Memorandum

Subject SFS – Driver Ave Entry Lifts

The Sydney Football Stadium (SFS) is being redeveloped into a modern, world class venue by the NSW Government. As part of the Stage 2 works the design was released for public comment, with the feedback period ending in July 2019. As a result of the consultation and feedback process a question was raised regarding the lift capacity in the outdoor space / entry at Driver Avenue connecting to drop-off areas and the car parks. Arup has been engaged to review the lift service required for the SFS Driver Ave entry and provide our opinion as to the adequacy and appropriateness of the lift service.

Figure 42: Accessibility of Precinct Context

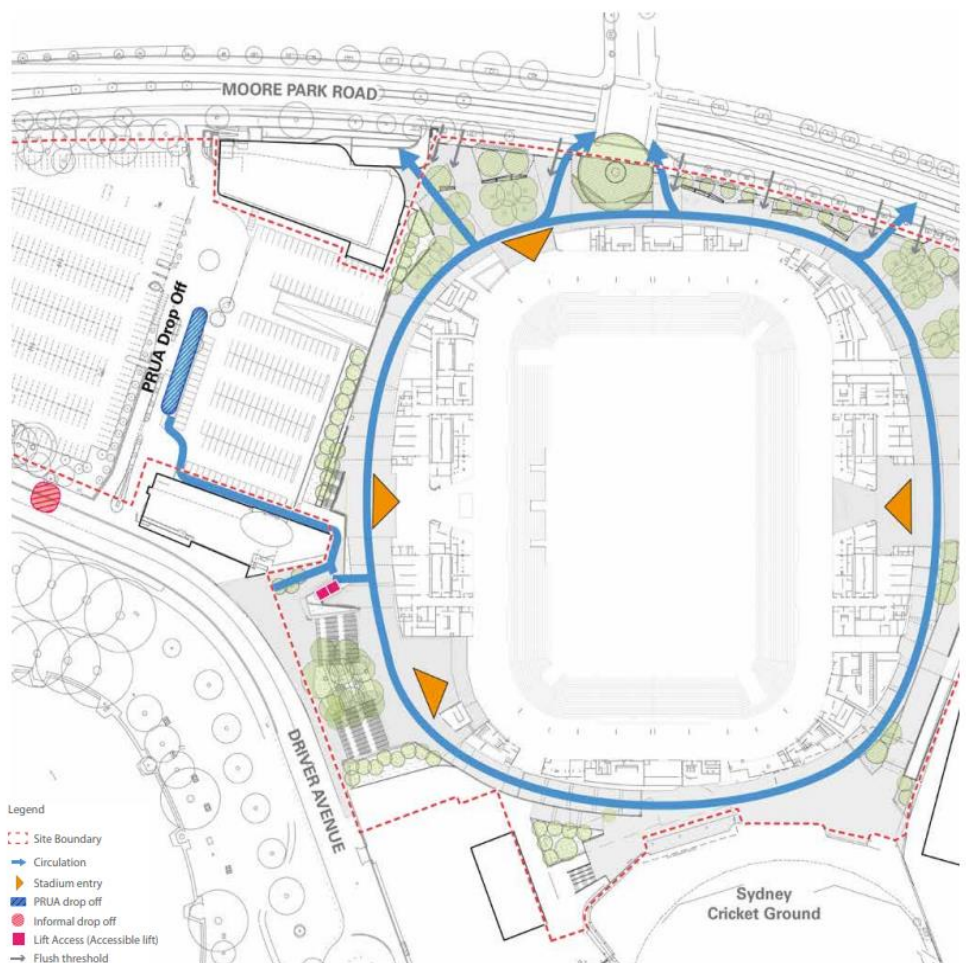
The plan below shows the location of the lifts to the west of the Stadium. The plan also shows that alternate entries / exits are provided for people who may wish to enter or leave in other directions. It is anticipated that the Driver Ave entry / exit will be the most used due to its connections with parking and light rail.

Elevate Graphical Results

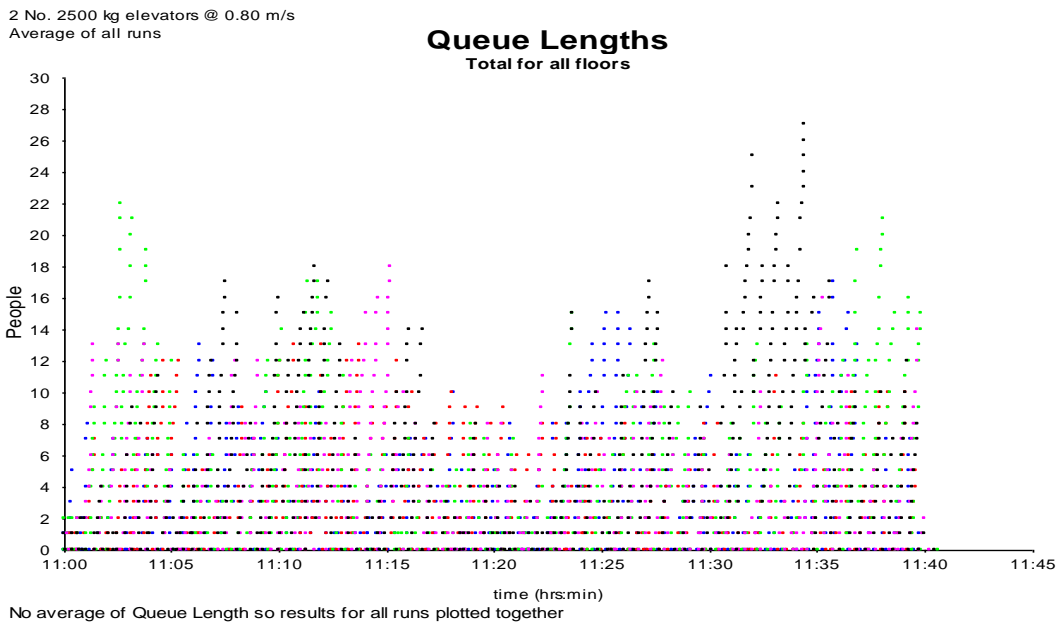
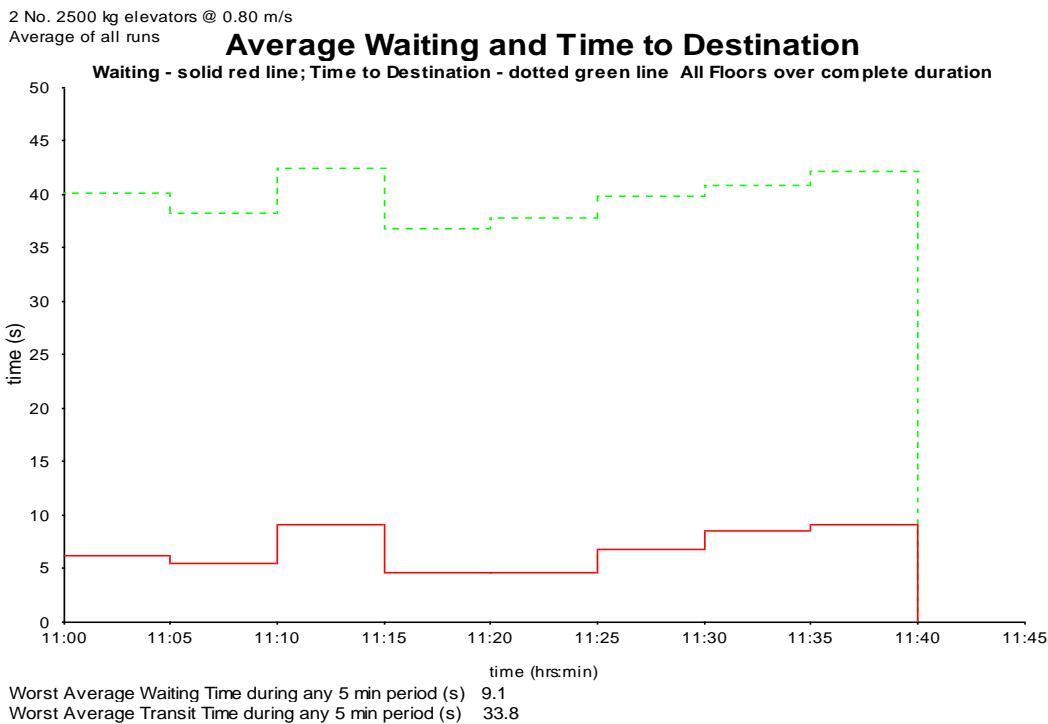
The graphs below are the output results from Elevate.

A significant number of persons may choose to enter or exit the Stadium via the Diver Avenue (West) side of the Stadium and a portion of these people may not be able or willing to use the stairs that are provided adjacent to the lifts. Our review shows that two lifts (of 33 passenger capacity) planned for this location will deliver adequate capacity for the anticipated number of lift-passengers. We note that lifts must have wide doors to make loading quick and easy.
